ACTIVITY DETERMINATION

Project No. BGX6L

Consolidation of lots and construction of a 2 storey boarding house consisting of 12 new generation boarding house rooms, on-site parking for 3 cars, 1 motorbike and 4 bicycles, landscaping and tree removal.

3-5 KELLOWAY AVENUE CAMDEN NSW 2570 - DHARAWAL COUNTRY LOT 17 DP 219782, LOT 18 DP 219782,

SCALE @ A3 1:200	PROJECT NO. BGX6L	STAGE AA	DRAWING NO. A105	REV 01
DRAWING TITLE SITE PLAN

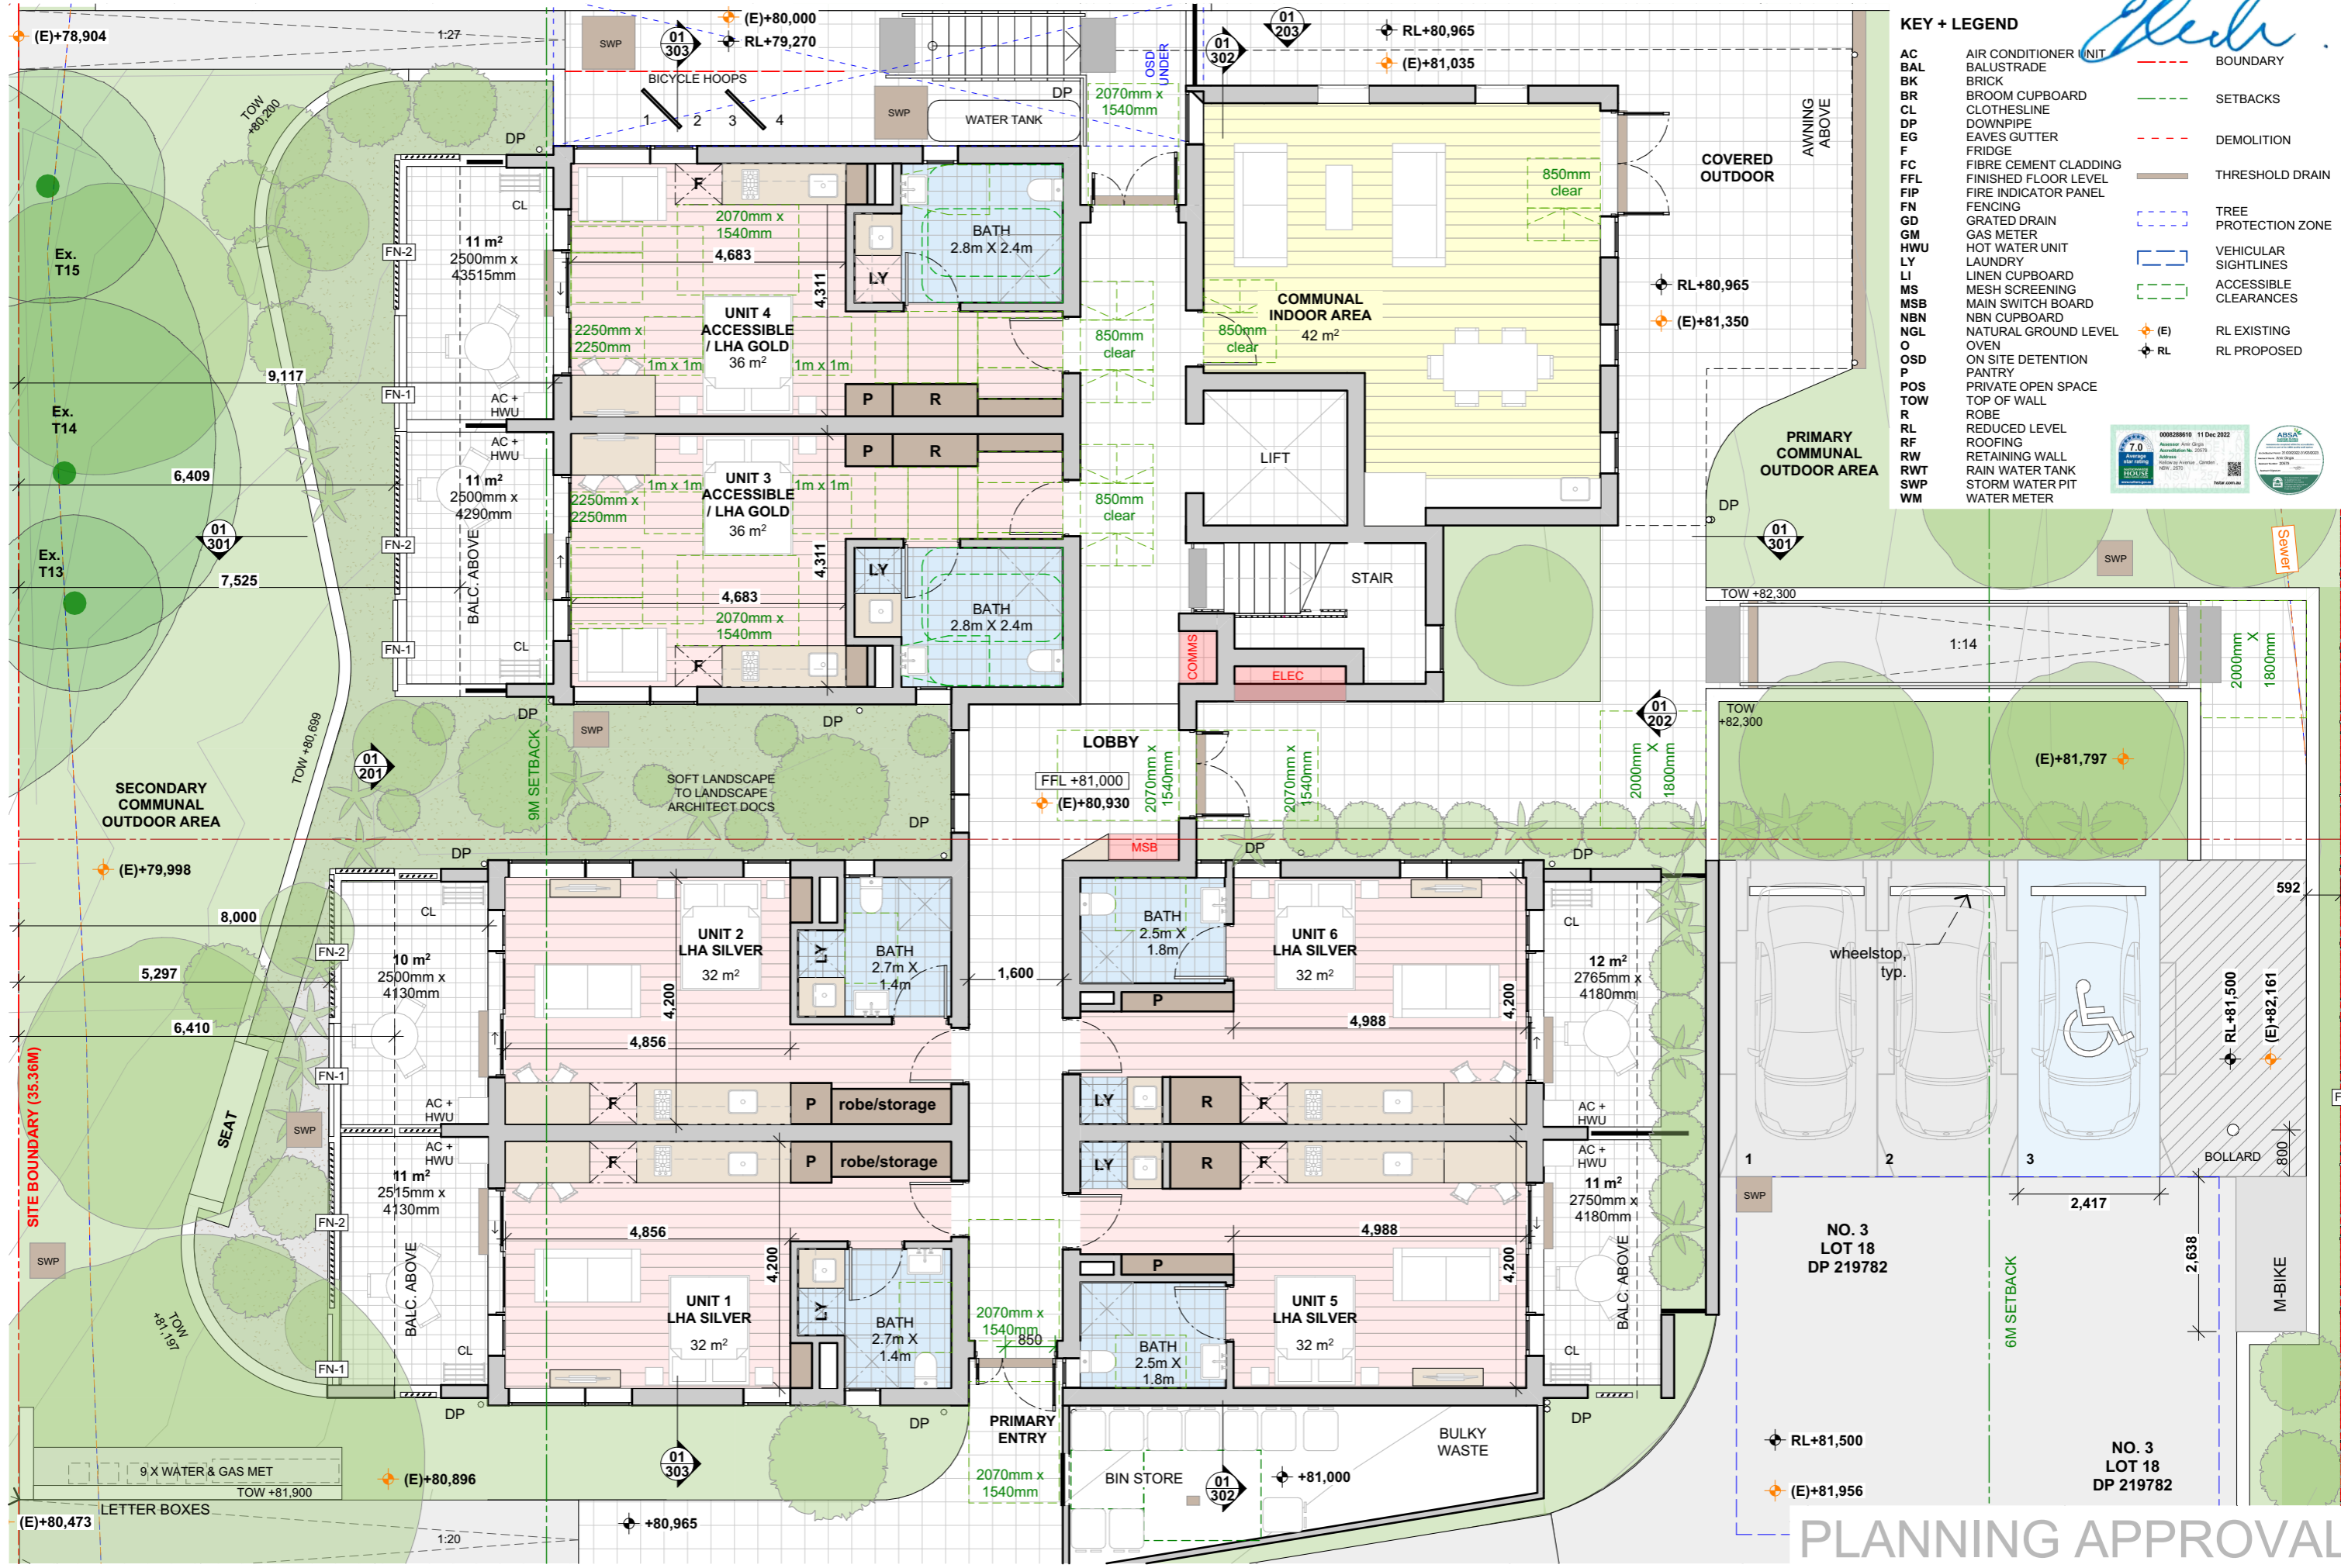
62. All Architectural, Landscape and Civil Plans are to be updated to reflect the 1m minimum clearance from the driveway to the stormwater street pit located at the street frontage consistent with the Site Plan (Plan No A105 Rev 01).
